November 20, 1996  
JPN-96-045

SUBJECT: **James A. FitzPatrick Nuclear Power Plant**  
**Docket No. 50-333**  
**Incorrect Attachments Included with Response to Request**  
**for Additional Information on Power Uprate**

REQUEST FOR ADDITIONAL INFORMATION REGARDING POWER UPRATE

JAMES A. FITZPATRICK NUCLEAR POWER PLANT

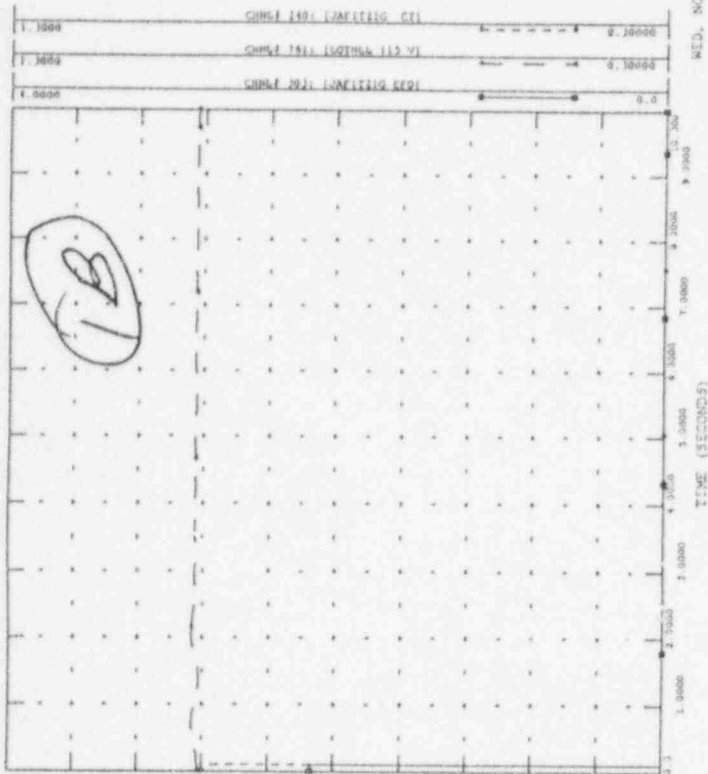
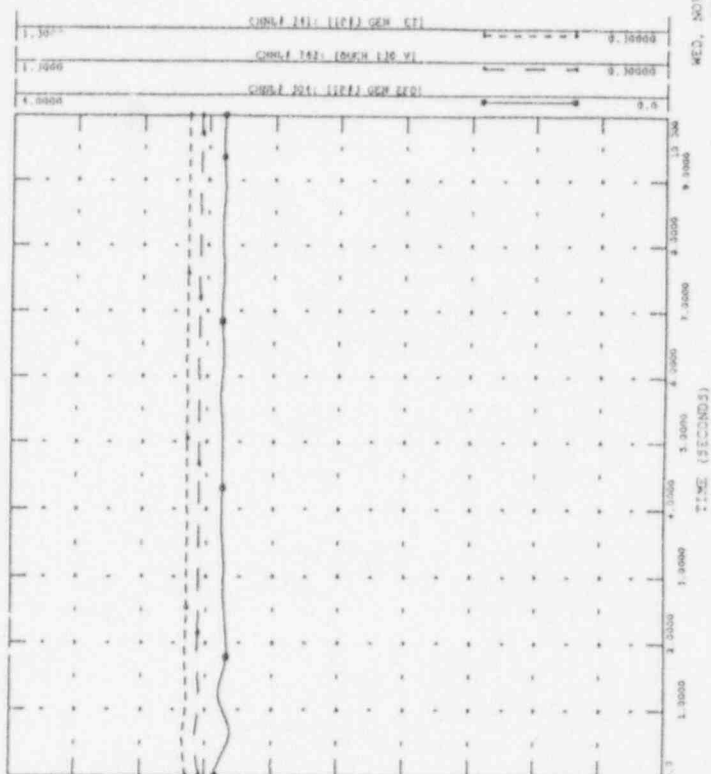
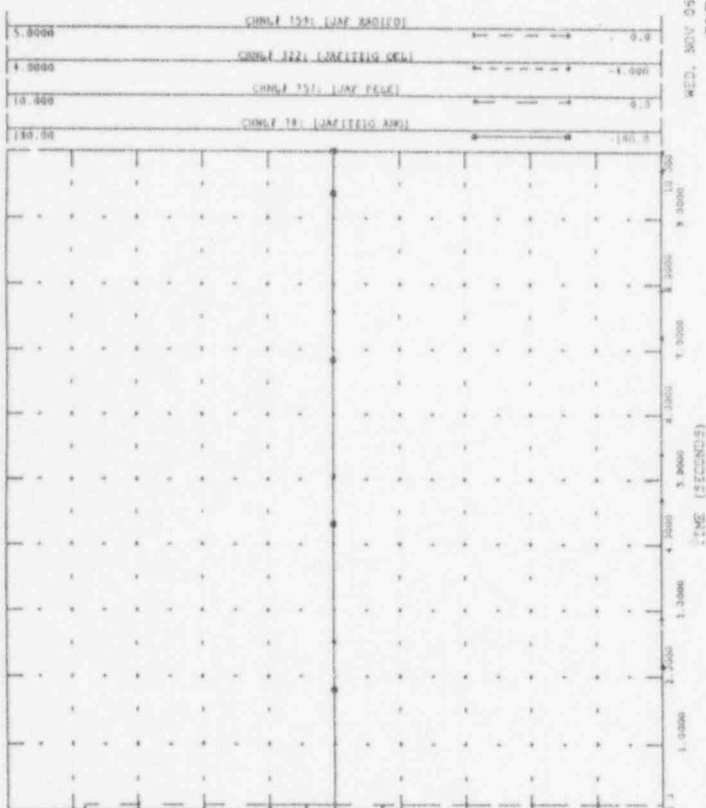
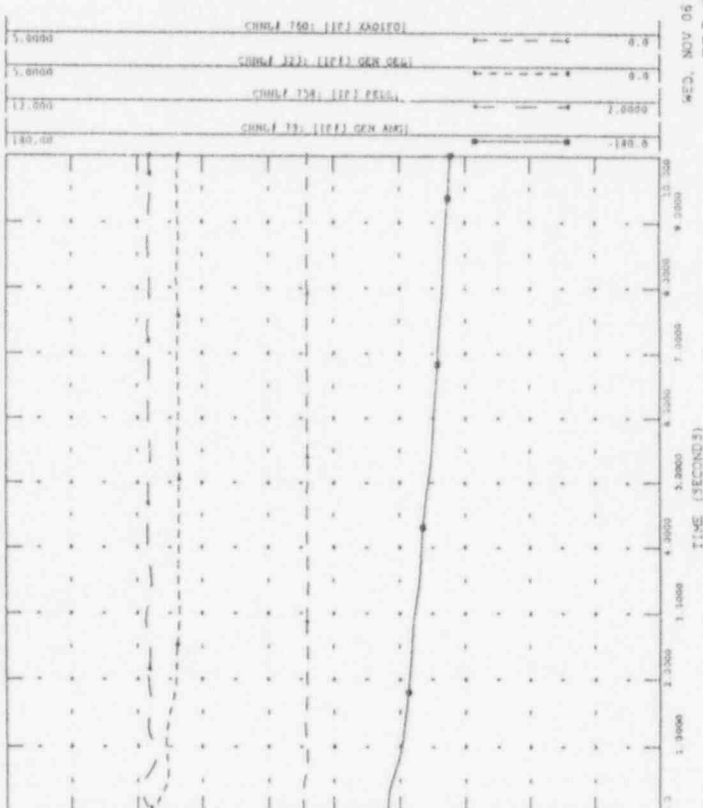
Does the offsite and the onsite power distribution systems/grid stability conform with GDC17, Appendix A to 10 CFR Part 50?

Stability simulations were conducted with the FitzPatrick unit loaded to 883 MW gross electrical output. Stability swing curves (Curves 1A and 1B attached) show well damped and stable results for a loss of FitzPatrick generation. Stability swing curves (Curves 2A and 2B attached) show well damped and stable results for the most severe normal criteria contingency (i.e., stuck R935 breaker at Scriba).

Based on the revised operating guidelines that will be in place, the FitzPatrick unit will remain stable under power uprate conditions.
